1819 WEST 5<sup>TH</sup> AVENUE (COMPLETE APPLICATION)  
DE417855 - ZONE C-3A

**DEVELOPMENT PERMIT STAFF COMMITTEE MEMBERS**

**DEVELOPMENT PERMIT STAFF COMMITTEE RECOMMENDATION: APPROVE**

SHEET NO.	A22
DATE	OCT 28, 2014
DRAWN BY	[Name]
CHECKED BY	[Name]
PROJECT NO.	1323

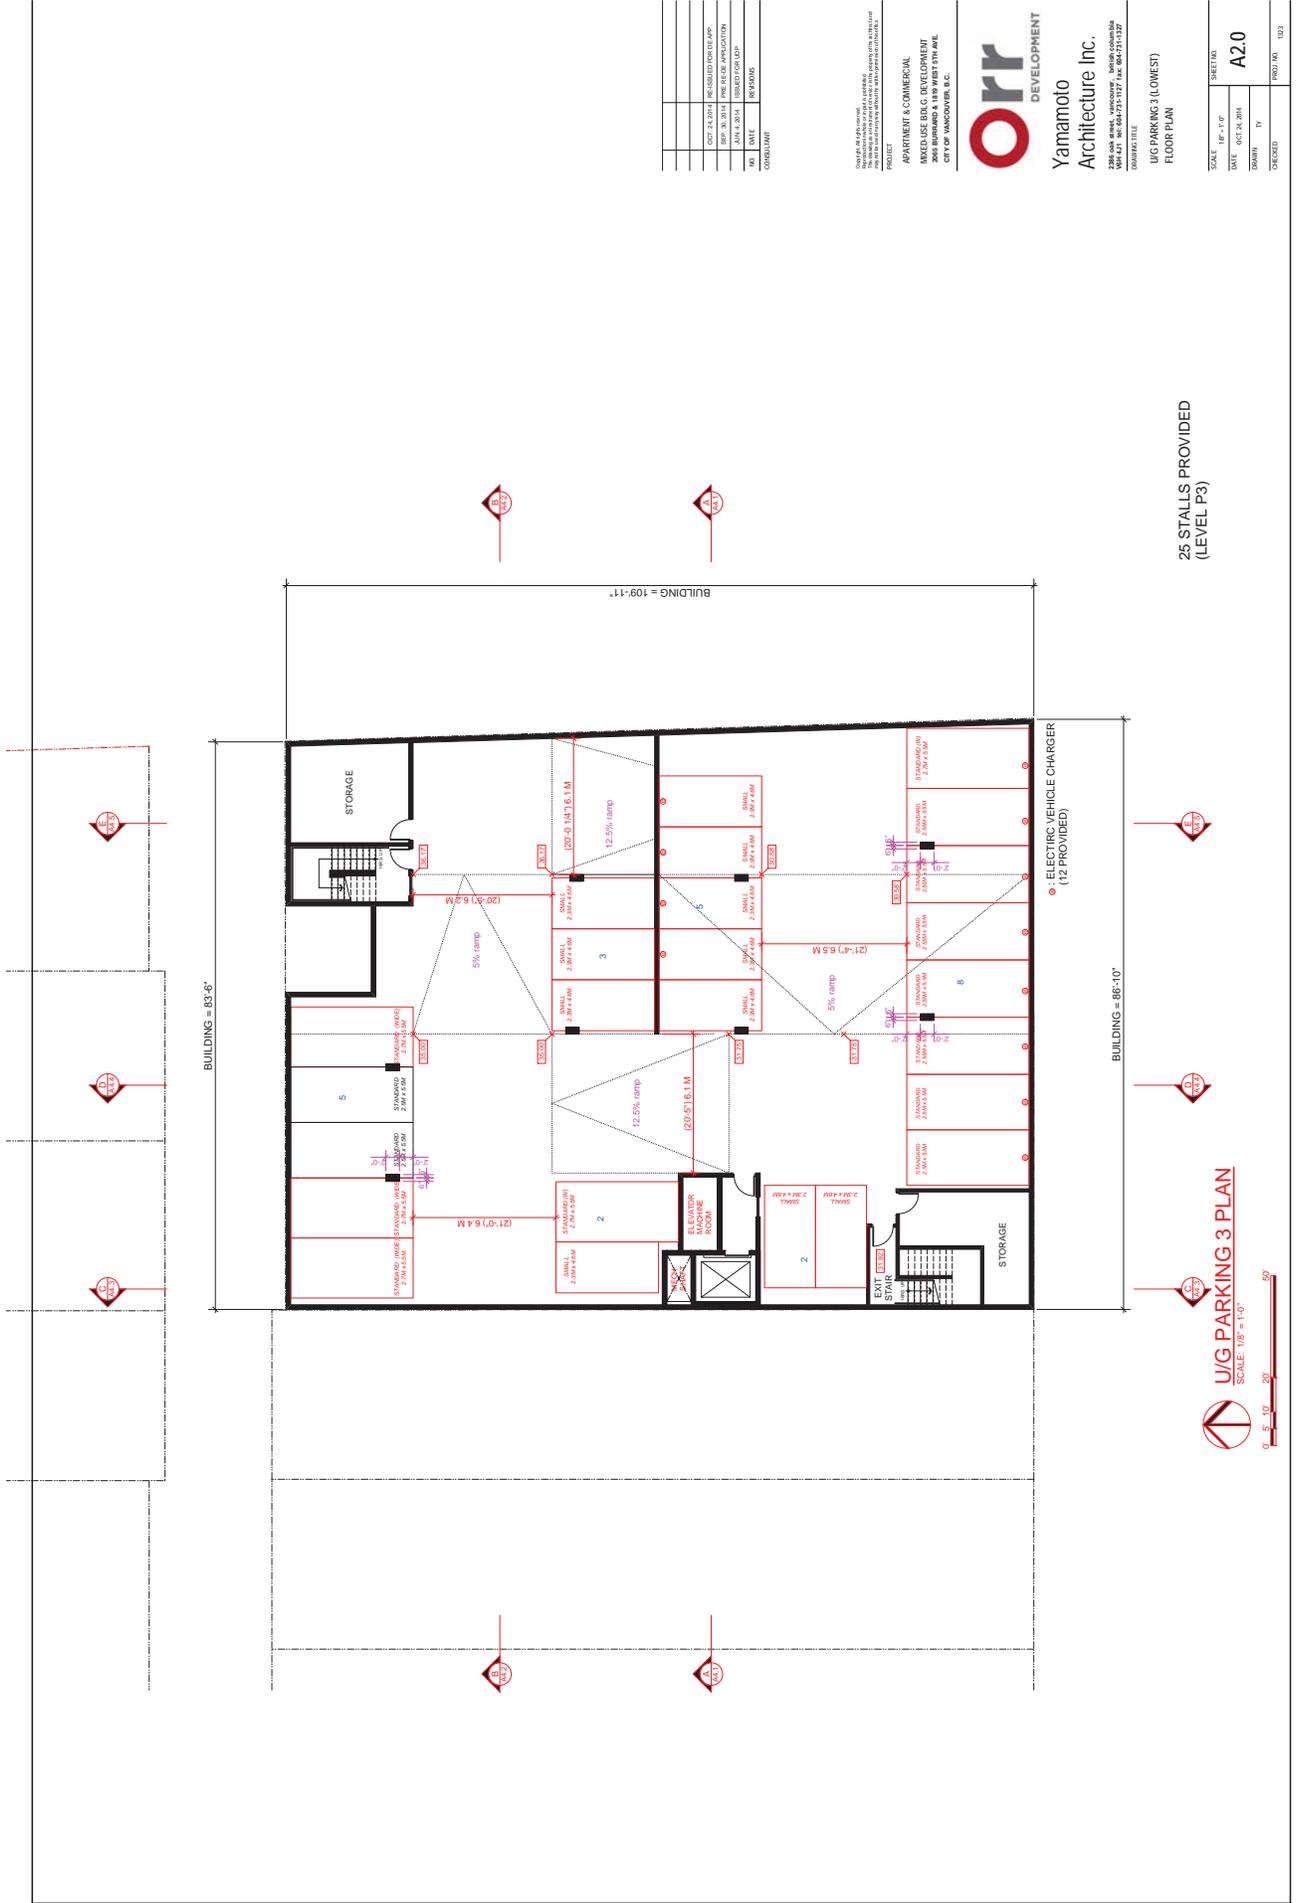
**Note to Applicant:** Proposed stacking bicycle racks proposed for residential use on drawing A2.2 do not meet Parking By-law.

SHEET NO.	A2.3
SCALE	1/8" = 1'-0"
DATE	07/25/2014
DRAWN BY	TY
CHECKED	
PROJ. NO.	1323

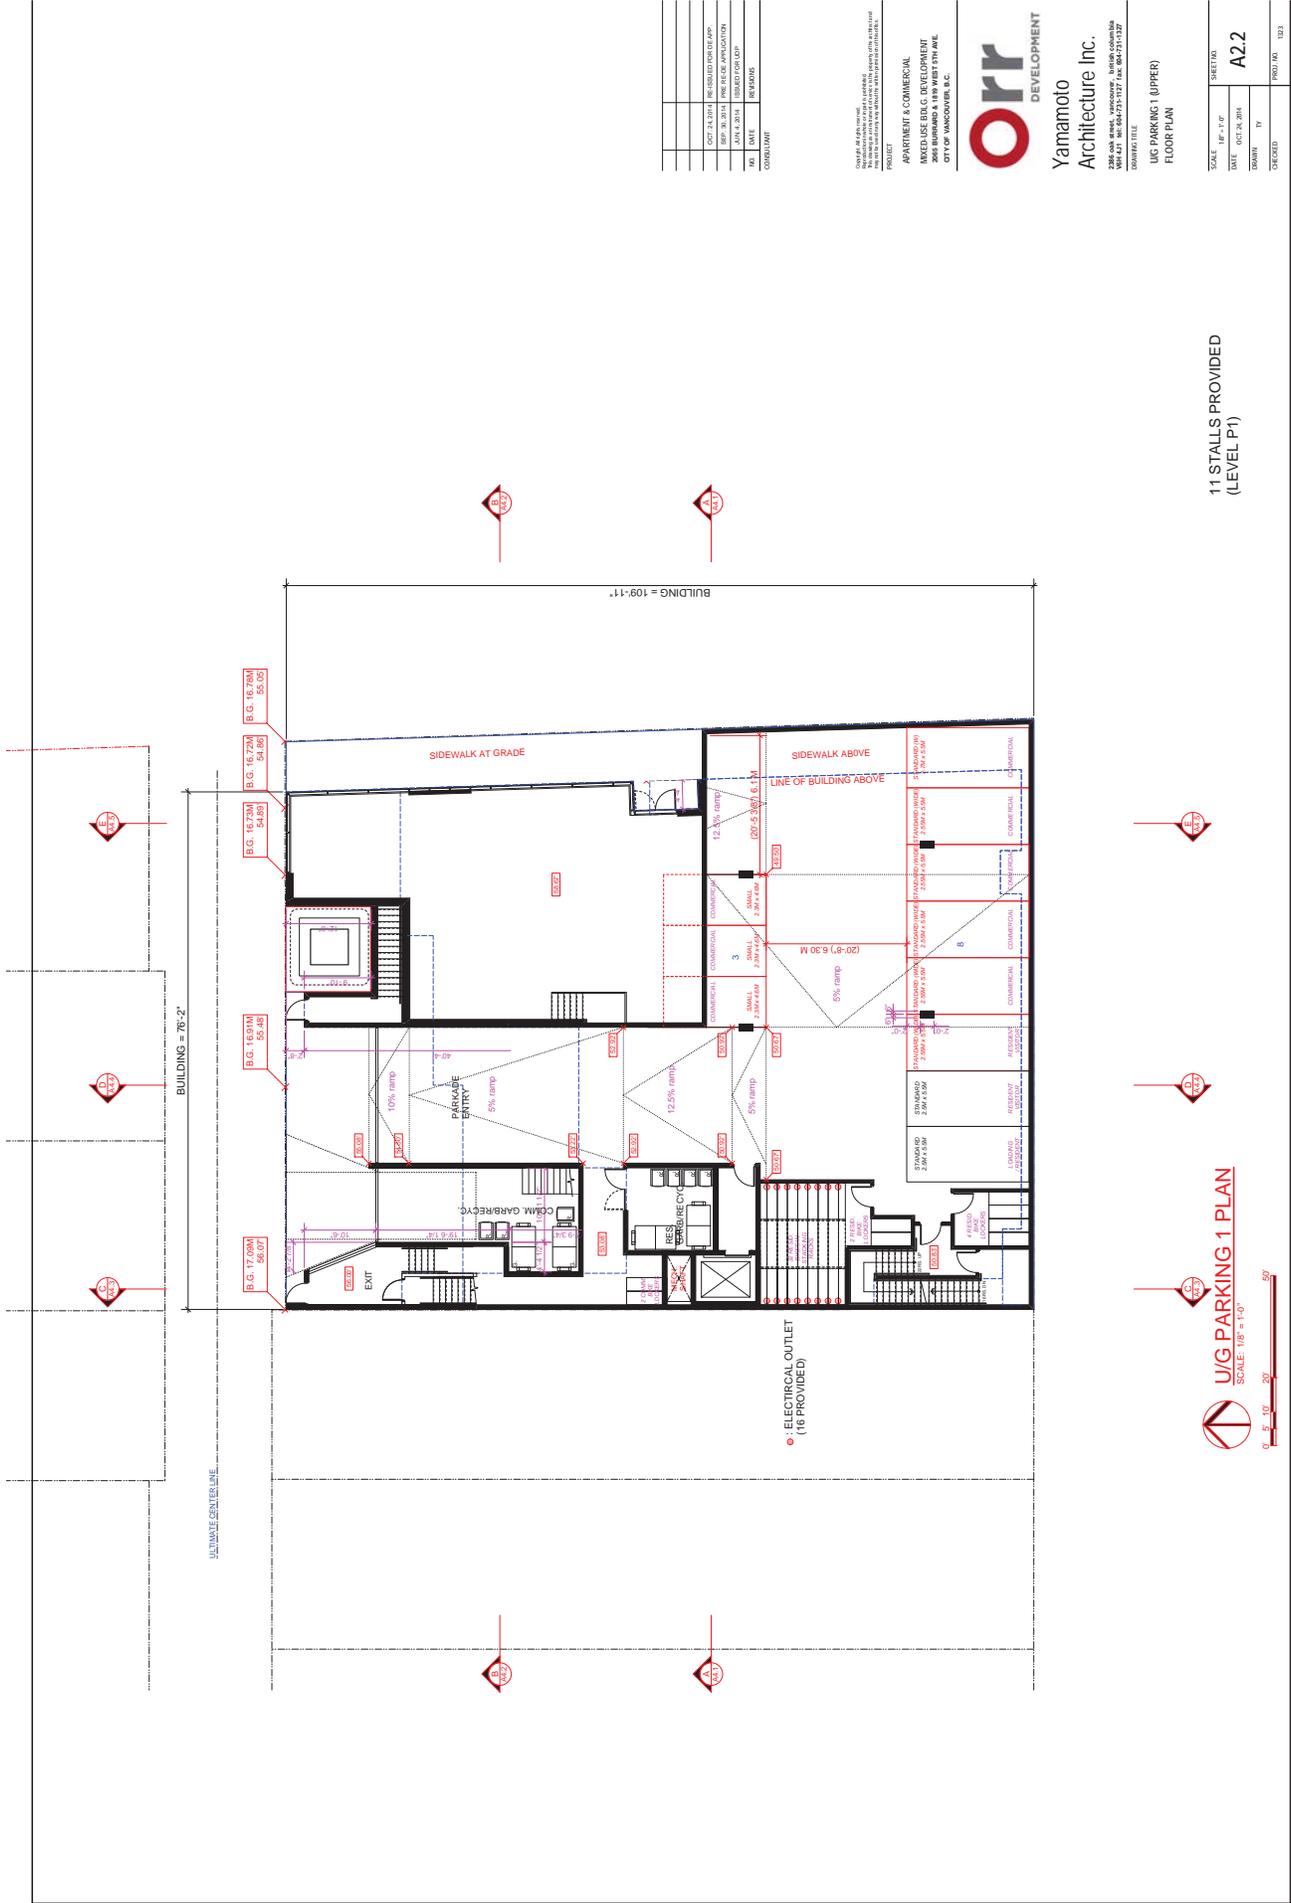
- iii. provision of a loading dock, lift, or elevator to provide a 'stairs free' access from the Class B loading space to the loading corridor;
- iv. provision of a section drawing showing elevations, vertical clearances, and security gates through the Class B loading bay;
- v. modification of the loading bay design to reduce the slope to 5 %;

**Note to Applicant:** Using the design elevations shown on drawing A2.3, the slope calculates to 6.8 %.

**ROOF PLAN**  
 SCALE: 1/8" = 1'-0"  
 0' 5' 10' 20' 30' 40' 50'

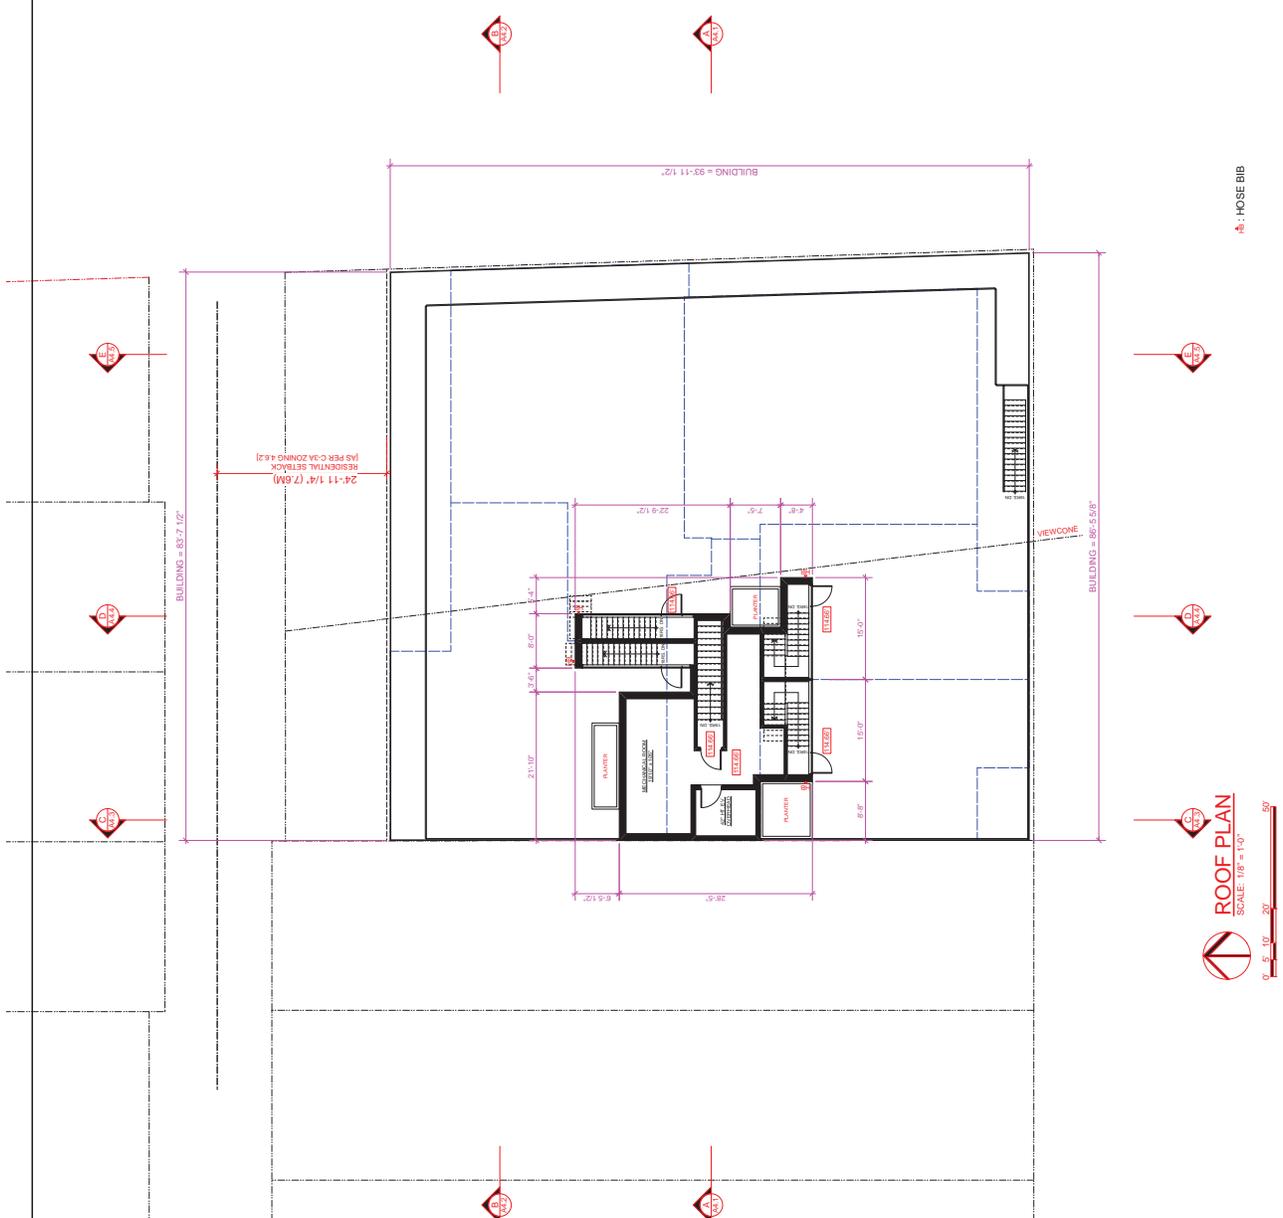
A.1.7 confirmation that the roof plan matches the elevation plan;

**Note to Applicant:** The guard rails do not match when comparing the elevation plans and roof plan.
